Subject: Revised Request for Modification of the Phased Section 404 Individual Permit and Section 401 Individual Water Quality Certification for the construction of the Triangle Expressway Southeast Extension from NC-55 Bypass in Apex to I-40, Wake and Johnston Counties. TIP Nos. R-2721, R-2828, and R-2829. Federal Aid Project No. 0540047.

We are requesting a modification to the Section 404 Authorization (SAW-2019-02240) and the associated 401 Water Quality Certification (Permit No. 20181249). This request is necessary due

Revised Table 5. R-2829A Jurisdictional Resources Impacts

SITE 13

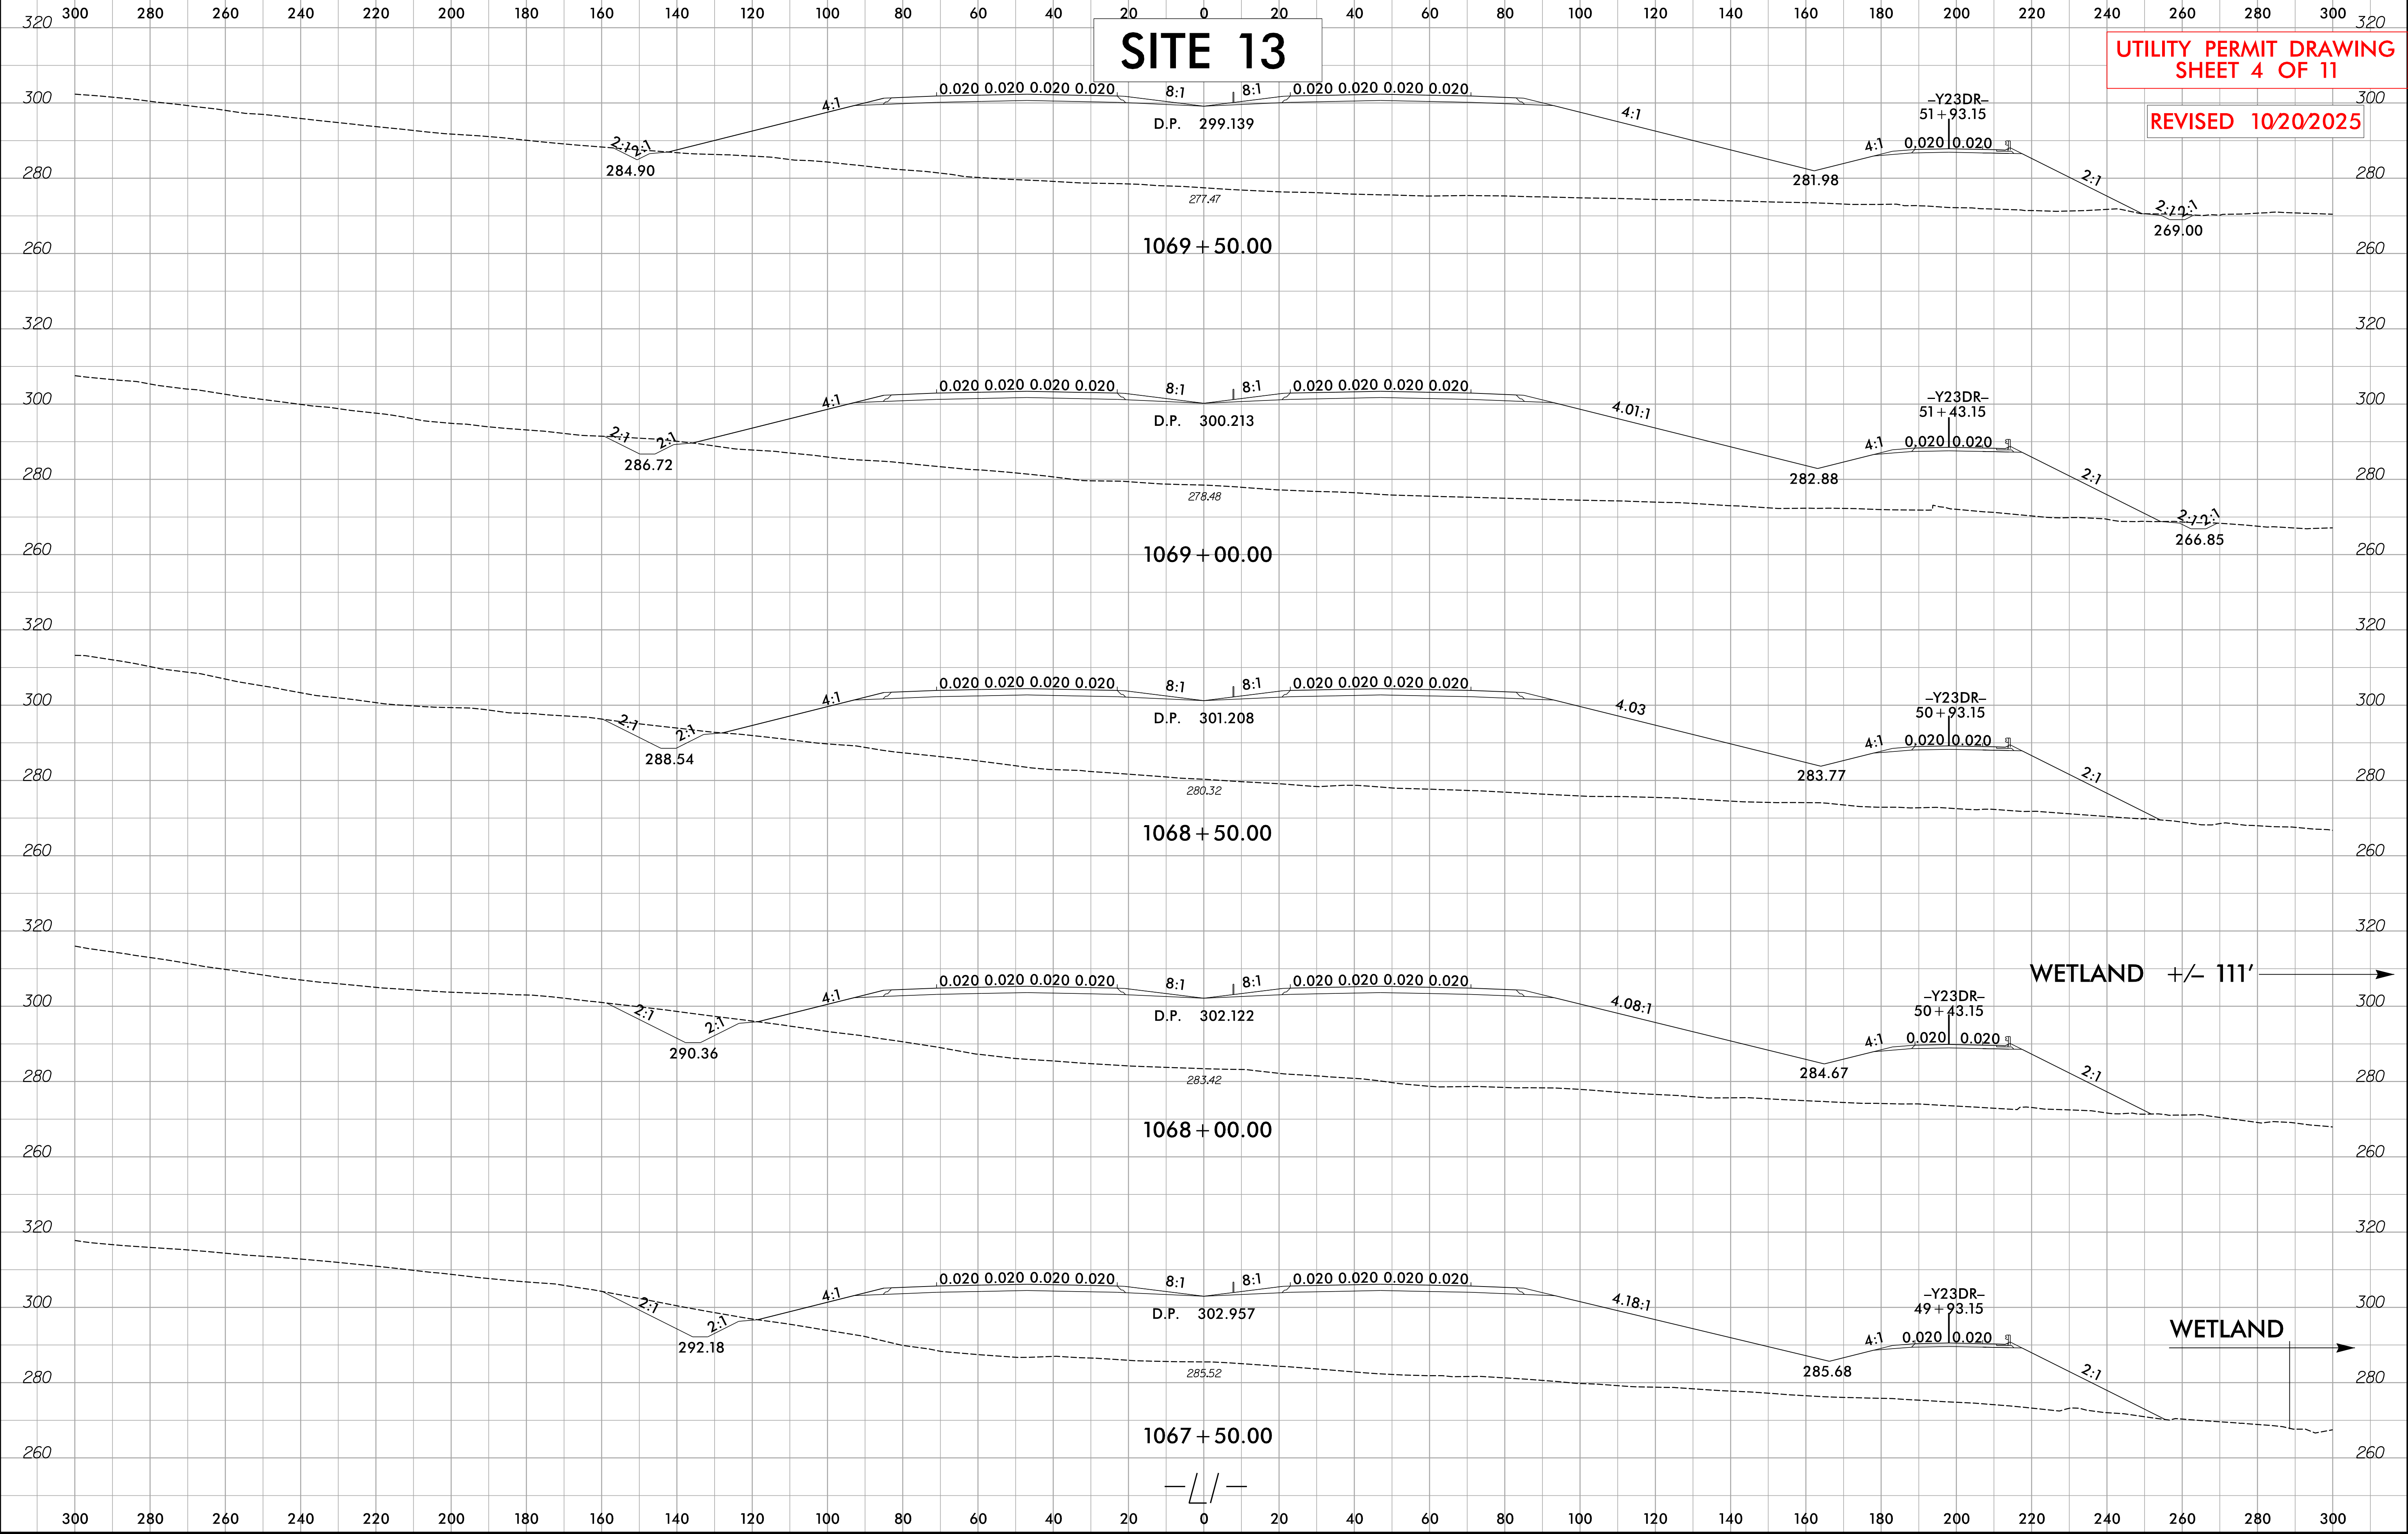
- Hand clearing in wetlands: 0.032 ac (previously 0.000 ac, increase of 0.032 ac)

Utility Site 13

Duke Energy (overhead) power lines will be relocated within an easement that will be shared with Spectrum (overhead) and AT&T (overhead) and MCI/Verizon (overhead), requiring hand clearing within wetland WGO, resulting in wetland impacts. No additional impacts to streams or riparian buffers will occur at this location.
